Response to request for information memo

Tilbuster Solar Farm

February 2022

Project Number: 20-729

Figure 2-2 Comparison of the Development Footprint presented in the Amendment Report and the updated Development following expansion of the New England Highway intersection upgrade; additional land will be subdivided as Council road reserve.

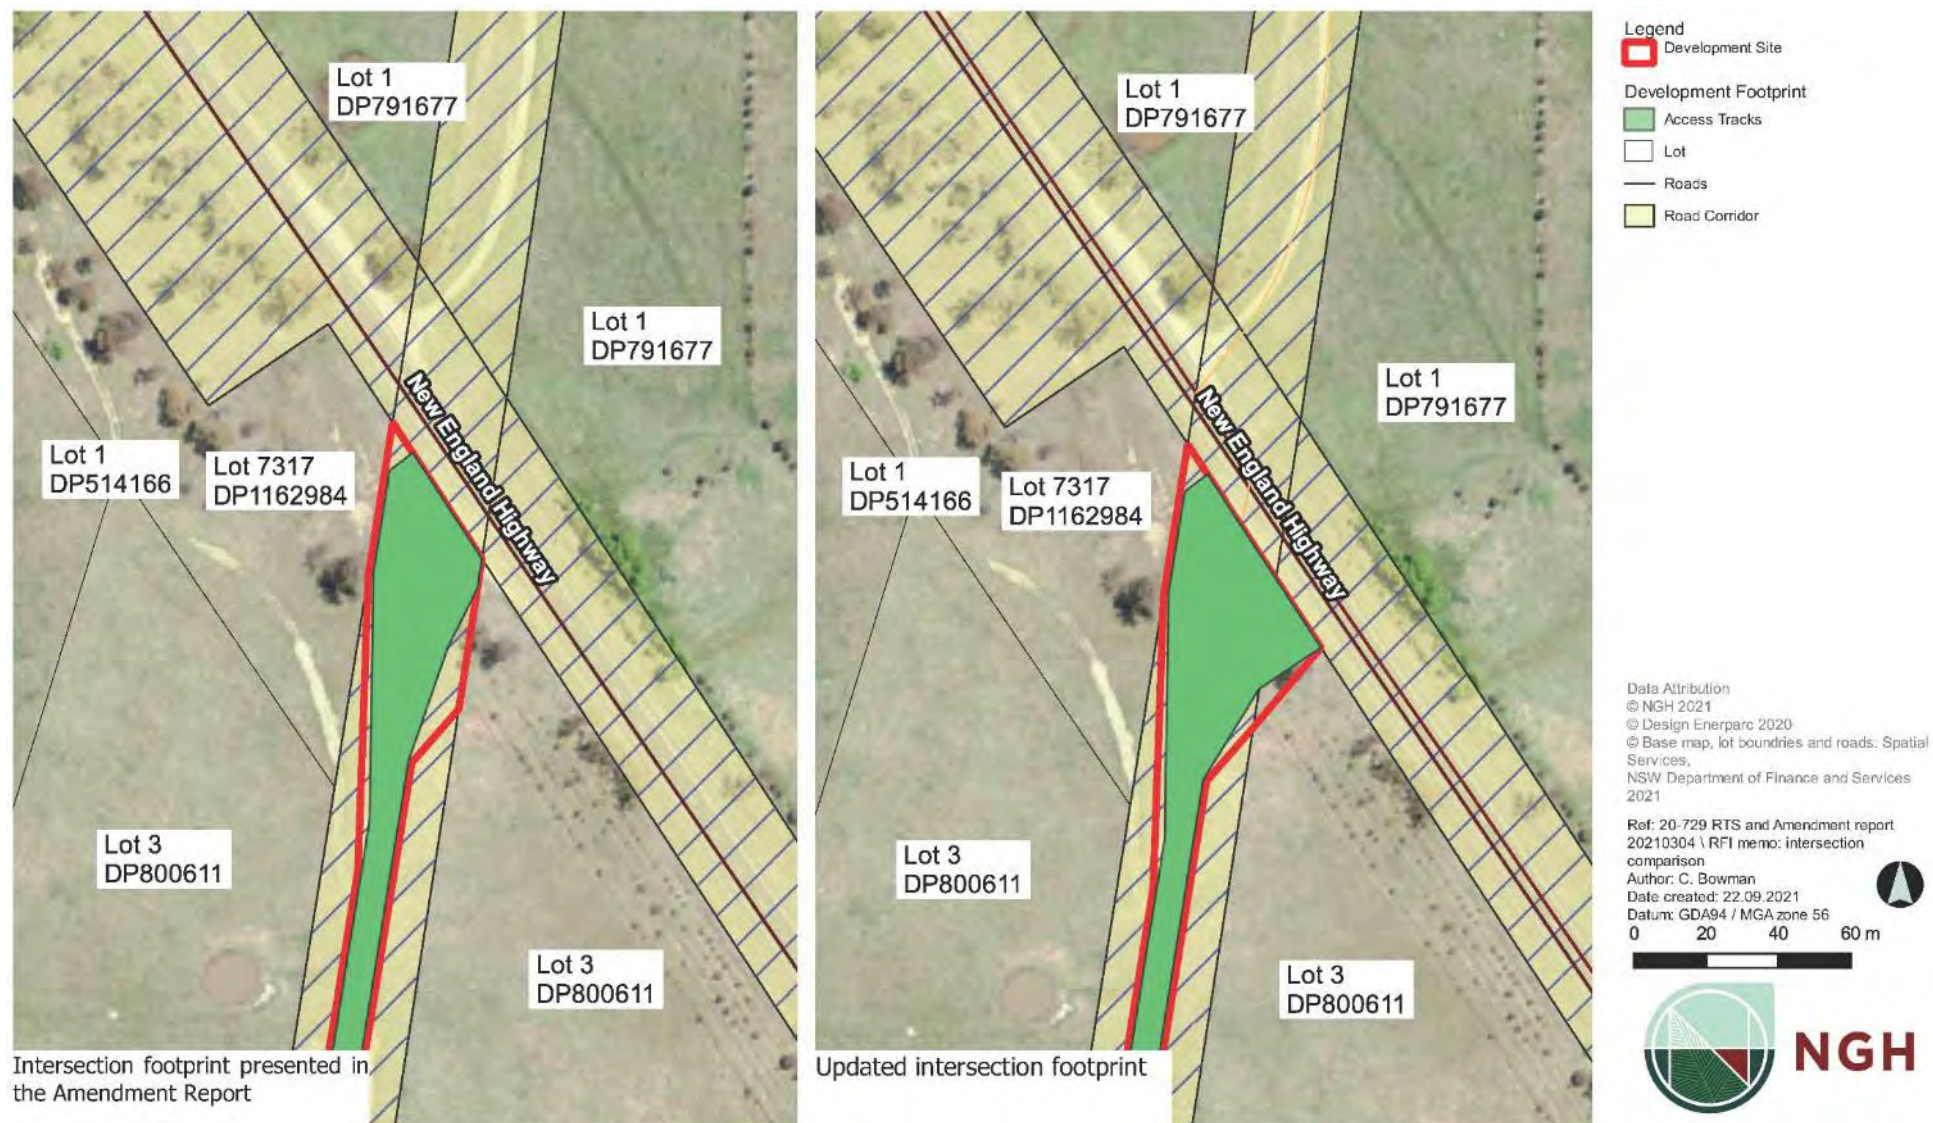
In relation to the intersection upgrades proposed in the Amendment Report, Armidale Regional Council requested that the Development Footprint should be further expanded to increase the distance between the road pavement and lot boundaries, and to provide additional space for drainage and other ancillary work, where the site access road joins the New England Highway.

- **Figure 2-2 intersection footprint.**
 - o provide evidence of engagement and agreement with Council; and
 - o consider amending the subdivision required for this project and if required; provide a description, justification and an amended subdivision map.

To address this, Enerparc have now extended both the Development Footprint and Development Site to the south by approximately 20 meters into Lot 3 DP 800611 (refer to Figure 2-2). This results in a minor increase to the Development Footprint and Development Site (which is reflected in the areas referenced in Sections 2.1 and 2.3).

The design of the intersection upgrade would be largely unchanged from the design presented in the Amendment report. However, the extension of the Development Footprint would allow additional room for ancillary infrastructure, and minor adjustment to the design, should they be required during the detailed design and permitting process. It is noted the intersection upgrade design presented in the Amendment Report is compliant with the Austroads Guidelines (Austroads, 2017) and would provide adequate space for safe access and egress for vehicles proposed to be used during construction, operation and decommissioning. This further expansion would only improve safety outcomes.

Figure 4-1 Sites in relation to Development Footprint

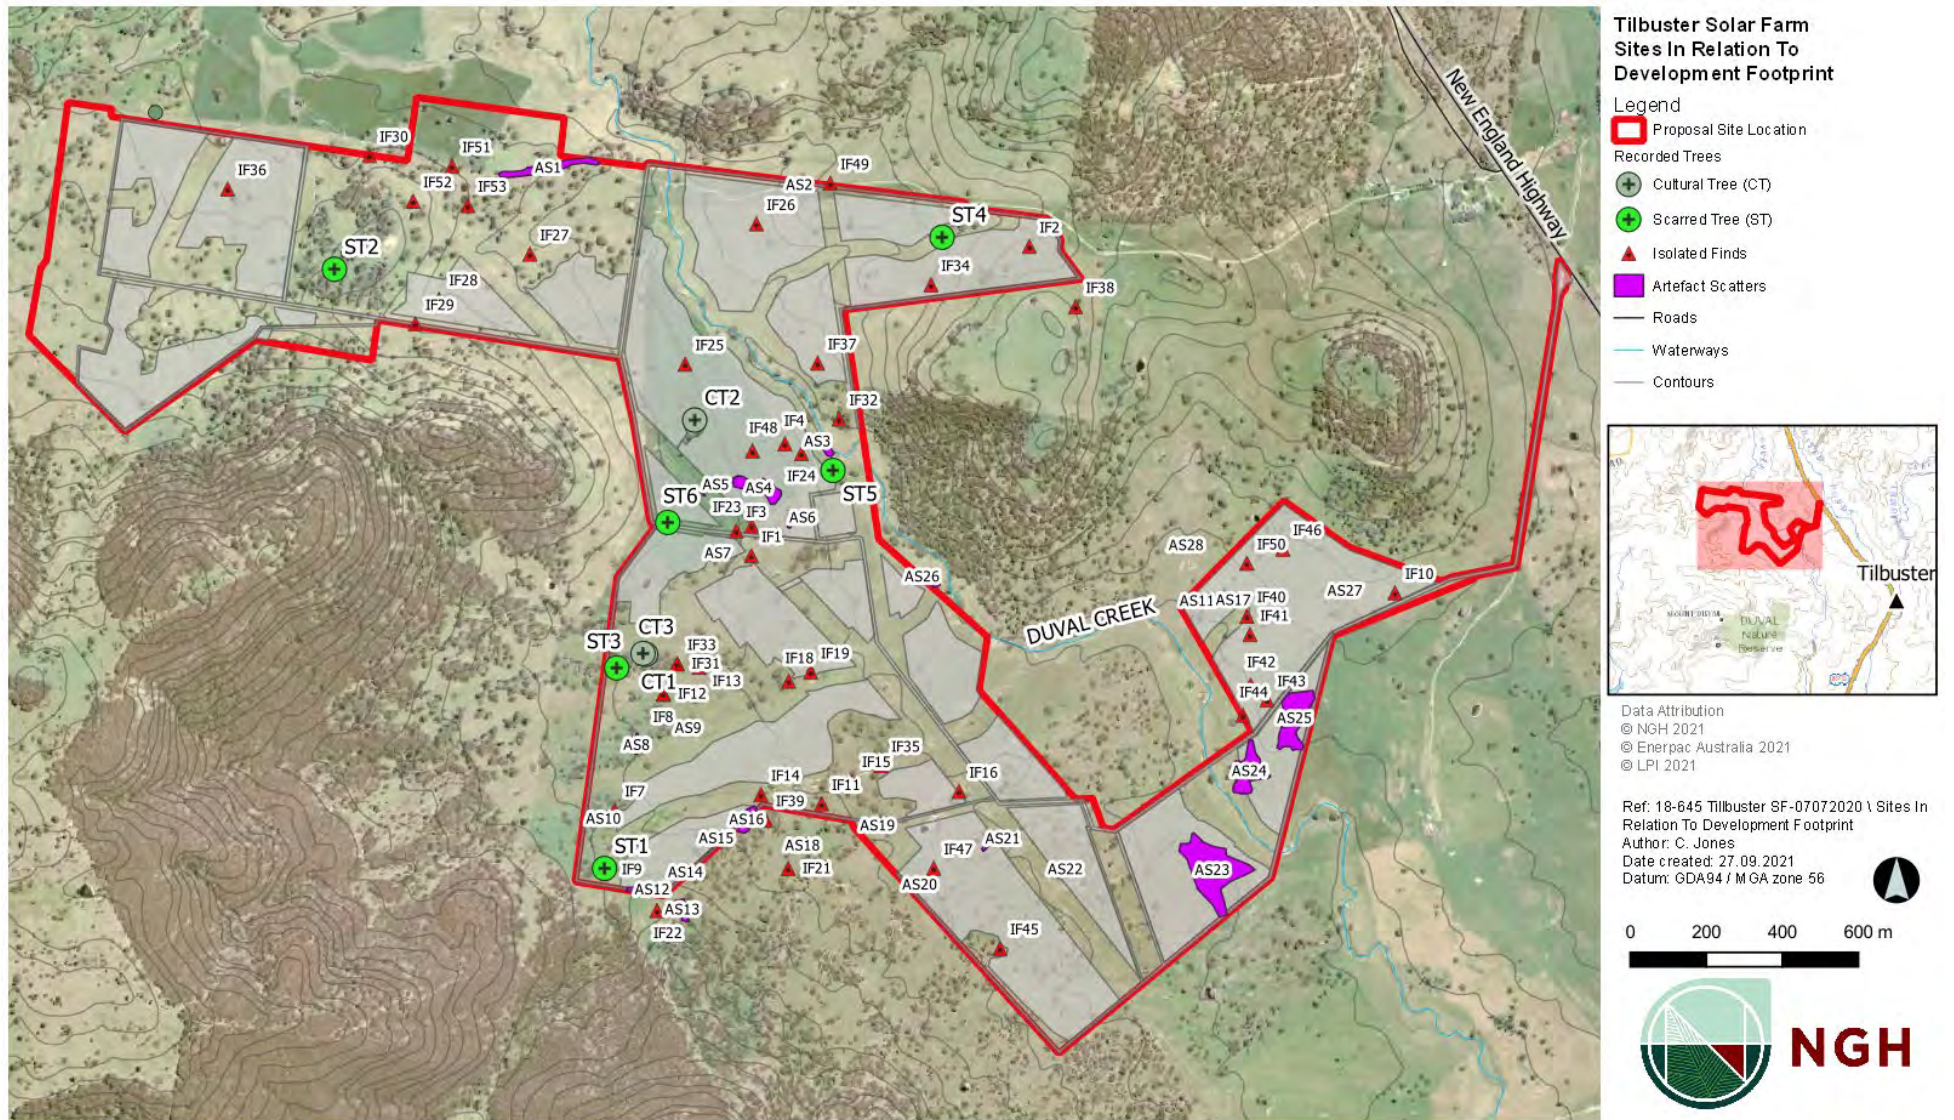
- item 9 in section 4.4 should take place prior to determination;
 - section 4.4 refers to likely indirect impacts to some items including CT4, CT4 needs to be appropriately described, assessed and included in tables and in the Figure 4-1; and

Based on the revised Development Footprint, as described in Section 2 of this report and presented in Figure 4-1. A complete assessment of each known Aboriginal heritage site's scientific values and identified risks has been updated, and is presented in Appendix H.
